3  
4  
5 ADVISORY COMMITTEE ON REACTOR SAFEGUARDS  
6 REACTOR FUEL SUBCOMMITTEE MEETING  
7

12 Wednesday, September 3, 1980

17 For the committee as part of the continuing  
 18 discussion of NUREG 0630, we have several presentations.  
 19 The schedule that you have before you suggests that Norm  
 20 Lauben will speak first. However, he has not made the  
 21 transit yet down from Bethesda, and we don't know where he  
 22 is. So we will make a change in schedule.

Fig. 10 Outline of flow blockage model.

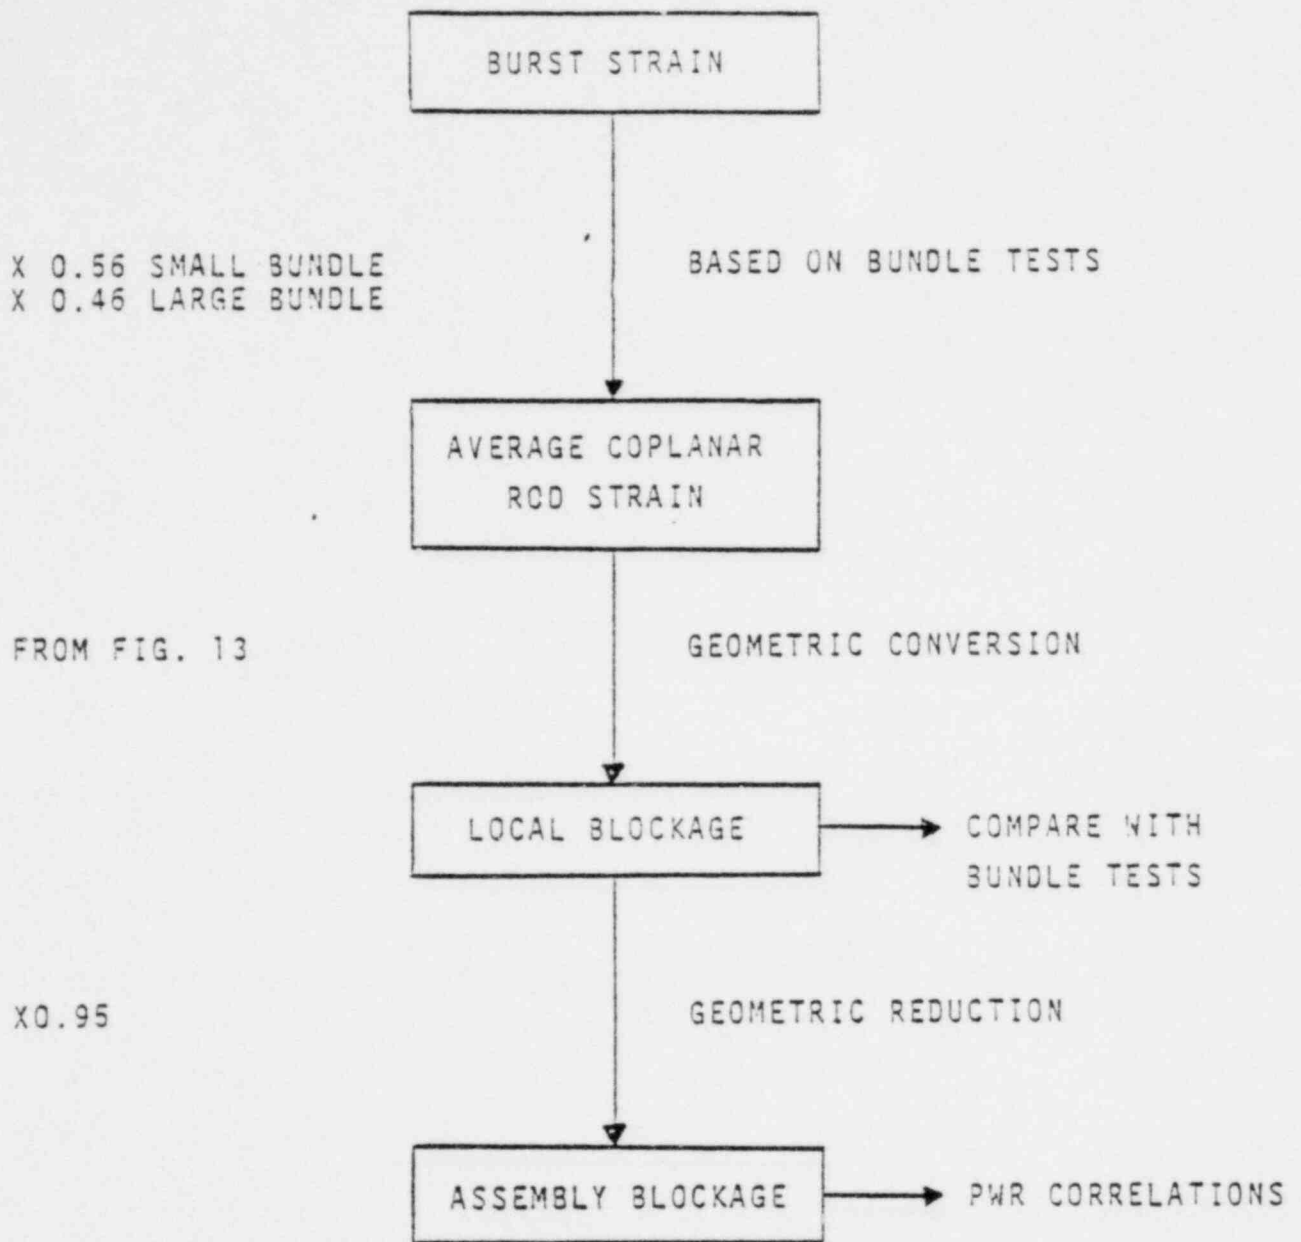
1           The first thing we should do is review the  
2 methodology, and this slide is Figure 10 from the NUREG  
3 report.

4           First, and starting from the top of the slide and  
5 working down, from three Oak Ridge multi-rod bundle tests we  
6 compared burst strains with average strain in a plane,  
7 finding the average strain to be about half of the burst  
8 strain. This average strain was then converted into a  
9 percent area blockage using simple geometrical assumptions  
10 that presumed that the fuel rods swell into square shapes  
11 after they touch.

15           The question was raised that deals with the first  
16 step of the procedure. The ratio between burst strain and  
17 average coplanar rod strain was based on only three Oak  
18 Ridge tests performed in the alpha phase temperature region.

2           Okay, the question that was raised was about this  
3 ratio of burst strain to coplanar average strains, and the  
4 question is you -- or maybe it is an observation -- that we  
5 took that ratio from three bundle tests, the only three  
6 bundle tests that existed at the time, and all three bundle  
7 tests were taken in the alpha phase region. And the comment  
8 was that as you move up through the mixed phase and into the  
9 beta region that you might expect that deformation in the  
10 burst node and deformation away from the burst node might  
11 get out of kilter a little bit, so that the ratio wouldn't  
12 hold.

21           And secondly, the alpha phase region appears to be  
22 the most important for the licensing analysis anyway. So we  
23 feel fairly comfortable in the region that is most  
24 important. It is the region of the biggest strains and  
25 where most of the plant transients fall down.
